BIDDING AND CONTRACT REQUIREMENTS ADDENDUM NUMBER (1) February 22, 2021

Re: ADDENDUM NUMBER (1) TO THE BIDDING DOCUMENTS:

Illinois Valley Community College Fireplace Lounge Accessibility Upgrades Architect's Project Number: 20-027

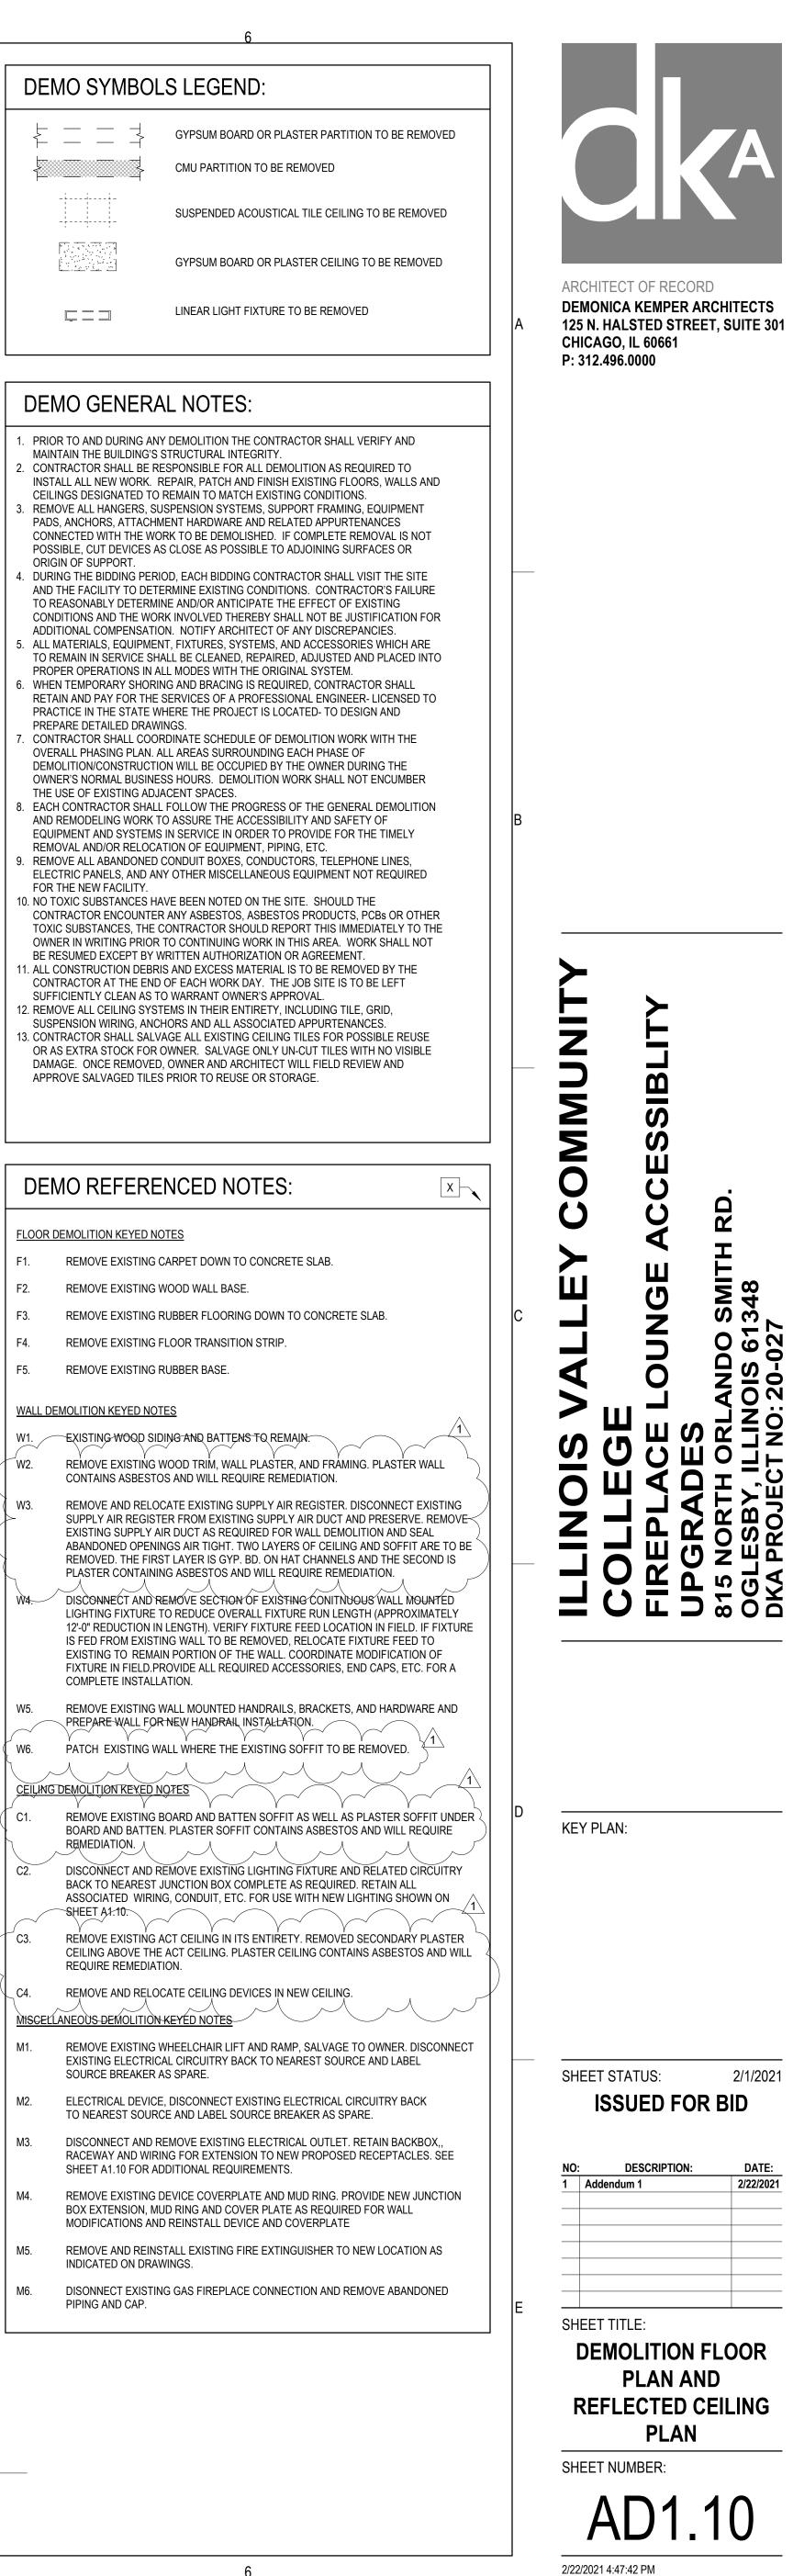
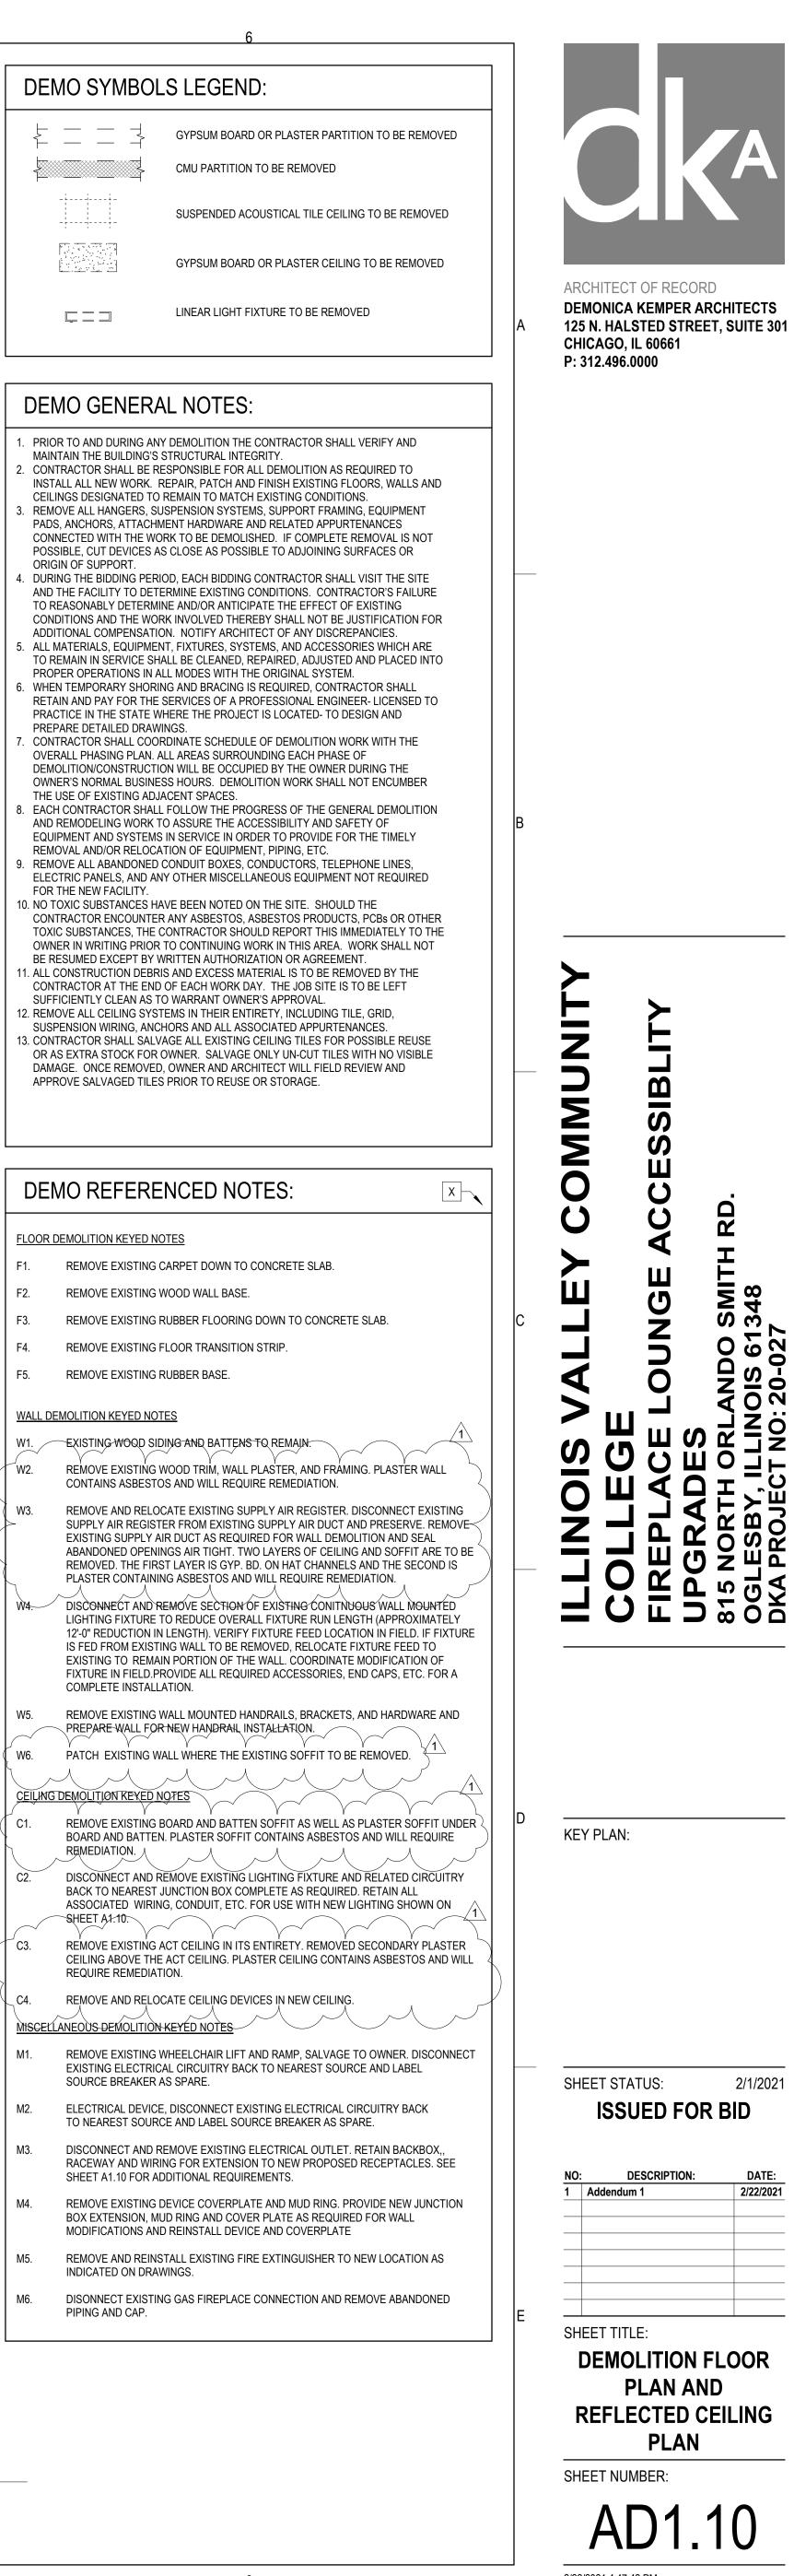
- 1. AD1.10
 - a. DEMO REFERENCED NOTES:
 - i. **REVISE** note W2 as follows: "REMOVE EXISTING WOOD TRIM, WALL PLASTER, AND FRAMING. PLASTER WALL CONTAINS ASBESTOS AND WILL REQUIRE REMEDIATION."
 - ii. REVISE note W3 as follows: "REMOVE AND RELOCATE EXISTING SUPPLY AIR REGISTER. DISCONNECT EXISTING SUPPLY AIR REGISTER FROM EXISTING SUPPLY AIR DUCT AND PRESERVE. REMOVE EXISTING SUPPLY AIR DUCT AS REQUIRED FOR WALL DEMOLITION AND SEAL ABANDONED OPENINGS AIR TIGHT. TWO LAYERS OF CEILING AND SOFFIT ARE TO BE REMOVED. THE FIRST LAYER IS GYP. BD. ON HAT CHANNELS AND THE SECOND IS PLASTER CONTAINING ASBESTOS AND WILL REQUIRE REMEDIATION."

- iii. **ADD** note W6 as follows: "PATCH EXISTING WALL WHERE THE EXISTING SOFFIT TO BE REMOVED."
- iv. **REVISE** note C1 as follows: "REMOVE EXISTING BOARD AND BATTEN SOFFIT AS WELL AS PLASTER SOFFIT UNDER" BOARD AND BATTEN. PLASTER SOFFIT CONTAINS ASBESTOS AND WILL REQUIRE REMEDIATION."
- v. **REVISE** note C3 as follows: "REMOVE EXISTING ACT CEILING IN ITS ENTIRETY. REMOVED SECONDARY PLASTER CEILING ABOVE THE ACT CEILING. PLASTER CEILING CONTAINS ASBESTOS AND WILL REQUIRE REMEDIATION."
- vi. **ADDED** note C4 as follows: "REMOVE AND RELOCATE CEILING DEVICES IN NEW CEILING."
- b. Detail 2, DEMOLITION REFLECTED CEILING PLAN:
 - i. **ADDED** WAP, Smoke Detector, and Diffuser to ceiling plan.

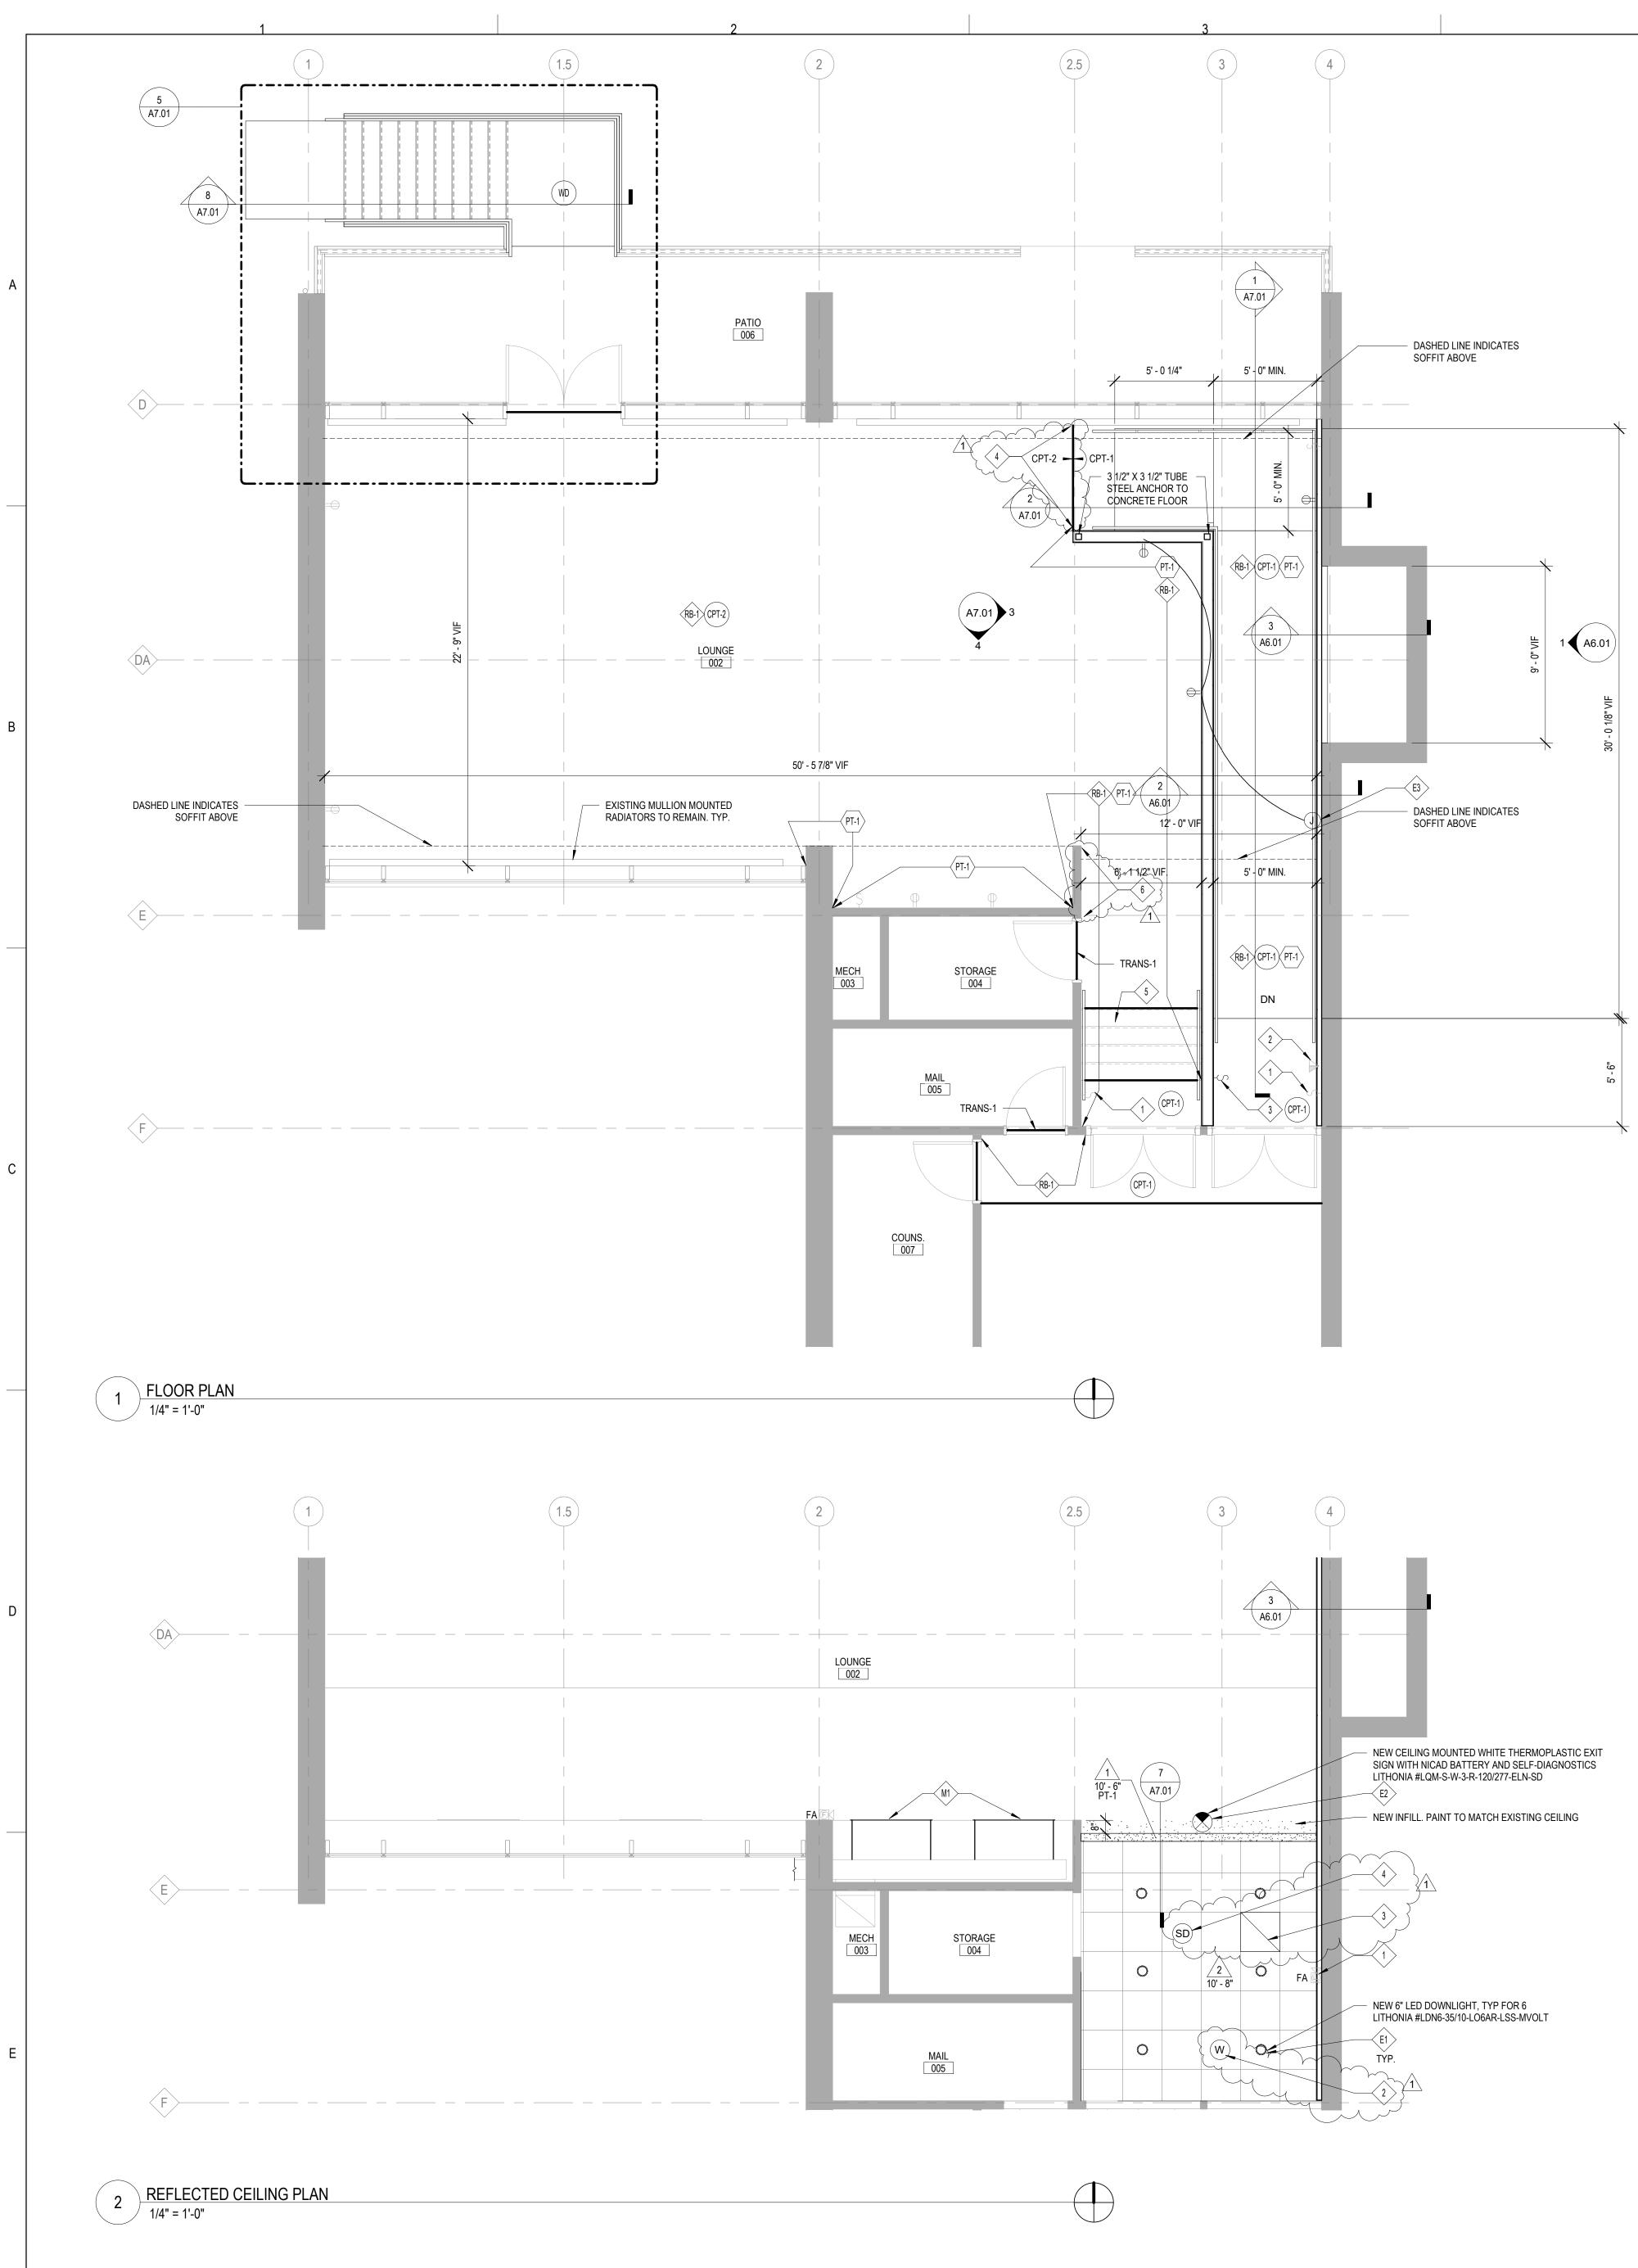
- a. RCP REFERENCED NOTES:
 - i. **ADDED** Note 2 as follows: "EXISTING CEILING WAP TO BE REMOVED AND REINSTALLED IN NEW CEILING GRID AND RETURN TO FULL OPERATION."
 - ii. **ADDED** Note 3 as follows: "PROVIDE NEW CEILING DIFFUSER TO MATCH EXISTING IN KIND AND SIZE, INSTALLED IN NEW CEILING GRID AND RETURNED TO FULL OPERATION."
 - iii. **ADDED** Note 4 as follows: EXISTING FIRE ALARM DEVICE TO BE REMOVED AND REINSTALLED IN NEW CEILING GRID AND RETURNED TO FULL OPERATION.
- b. FLOOR PLAN REFERENCED NOTES:
 - i. **ADDED** Note 6 as follows: "WALL INFILL FINISH BELOW SOFFIT TO BE TEXTURED TO MATCH ADJACENT SURFACES."
- c. FLOOR FINISH TYPES:
 - i. **ADDED** Floor Finish Name and Colors.
- d. FLOOR TRANSITION TYPES:
 - i. **ADDED** Floor Transition product.
- e. Detail 1: FLOOR PLAN
 - i. **ADDED** Key Note 4 at bottom of ramp.

- ii. ADDED Key Note 6 at wall below soffit.
- f. Detail 2: REFLECTED CEILING PLAN
 - i. **ADDED** Smoke detector to plan.
 - ii. **ADDED** WAP to plan.
 - iii. **ADDED** Diffuser to plan.
